PCN – Process Change Notification

Change:	FXR.05 Series
Date:	2018/01/23
Author	Bonnie Chen

Illustration of Change Old Design

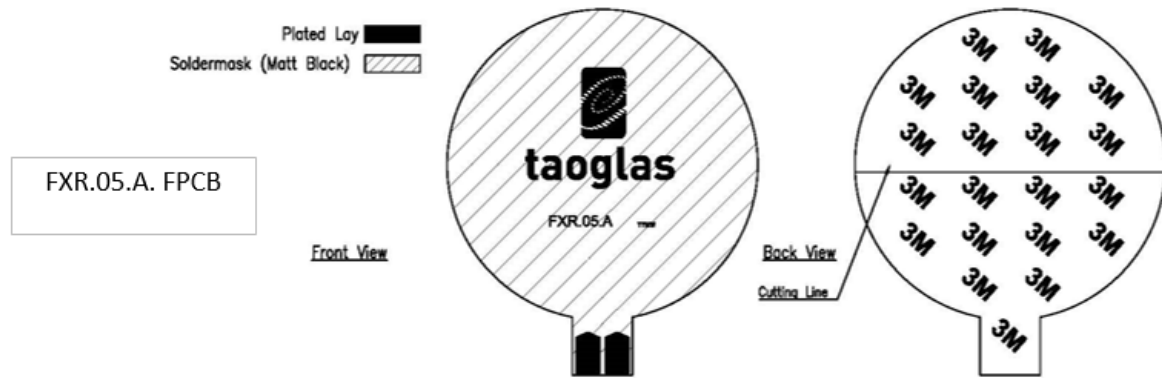
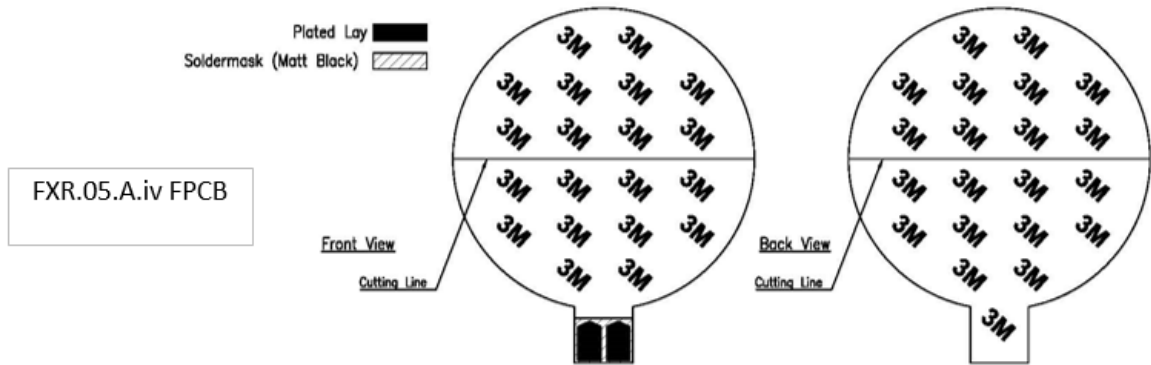
Model#	Part Number	Changes
FXR.05.A.iv FPCB FXR.05.A FPCB FXR.05.52.0030X.A FXR.05.52.0075X.A FXR.05.52.0075X.A.dg FXR.05.52.0075X.A.iv FXR.05.52.0170X.A.iv FXR.05.A FXR.05.A.dg	-	<ol style="list-style-type: none"> Reducing production failure rate, and add liner tear bar assist end customer assembly works. Amend FXR.05.A PAD from Sn Plated to Au Plated.

- Amend Liner Design.
- Amend Pad Design.
